1. INTRODUCTION

Tetra Tech's December 2014 report entitled Organic Management Consultant, Task 1 – Site Assessment, was peer reviewed by SLR in May 2016, and SLR's review was documented in a memorandum dated May 31, 2016. Subsequent to receipt of this memorandum, the RDOS requested that SLR review Tetra Tech's Task 2 report entitled Organic Management Consultant Task 2 – Feasibility Assessment, dated August 2015. Specifically, the RDOS requested that SLR's review focus on determining if the cost estimates presented were 'reasonable', since the Tetra Tech estimates would be used to support public consultation and by-law development activities, and in developing associated budgets. This memorandum presents SLR's review of Tetra Tech's Task 2 report, and our review comments follow.

Figure 1: Capital Cost Scale Factor (Tetra Tech)

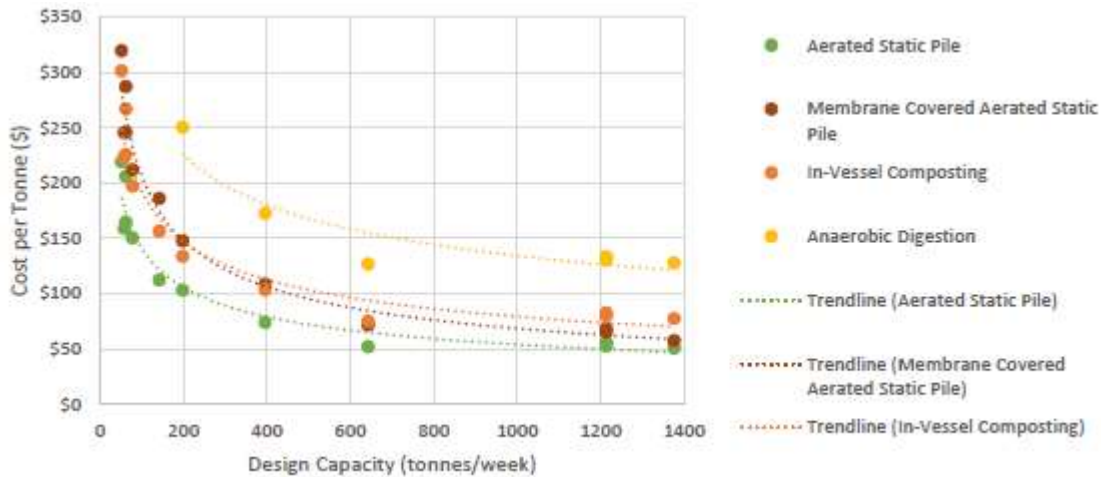
A plot of the data was presented in *Figure 1, p11* (reproduced as **Figure 1** below) of the Report that shows the cost/tonne decreasing with increasing size of facility, generally following a decreasing exponential trend, such that the larger the facility the higher are the cost savings due to the 'economies of scale' factor. On this basis the conclusion is that rather than single, site based facilities, it is worthwhile considering regional scale organics processing facilities that can

combine feedstocks from multiple sites. There is a natural limit to the benefits of the ‘economy of scale’ factor and the data presented suggests that once a facility reaches c.650tpw the cost/tonne benefit reduces significantly. For technologies that use pre-fabricated, modular units, the capital cost for larger facilities can actually increase.

Figure 2: European Capital Costs for IVC Plants [SLR]

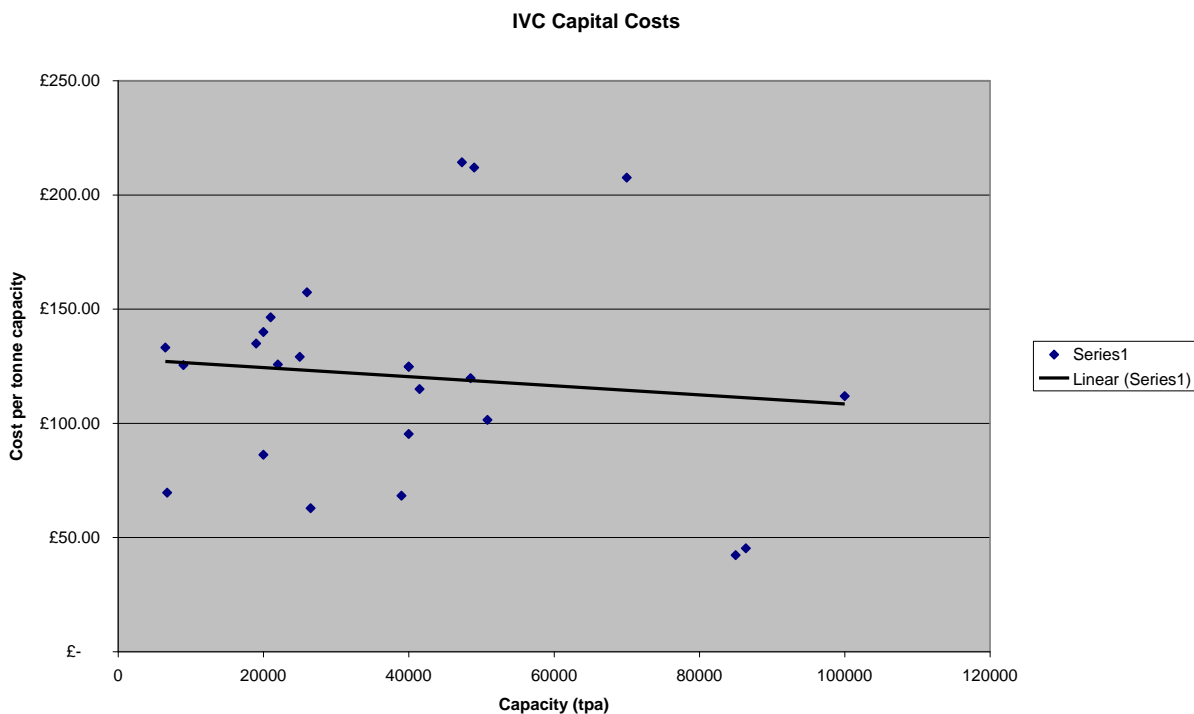
Figure 2 shows the results of a survey of the capital costs of IVC facilities in Europe of varying treatment capacities treating food and green wastes. IVC is rarely used in Europe to treat green wastes only.

The costs for a 20ktpa plant are in the range \$165-\$280/tpa, of which the lower cost aligns with the TetraTec cost data but the median European cost is c.\$200/tpa, roughly double the TetraTech estimate at c.\$100/tpa.

At the 40ktpa capacity the cost range is \$130-\$240/tpa with the median value c.\$200/tpa, compared to c.\$80/tpa in the TetraTech Report, more than double the cost.

The doubling of the capital cost ties in with the comments made above regarding treating mixed green waste and food wastes and the additional composting stage required.
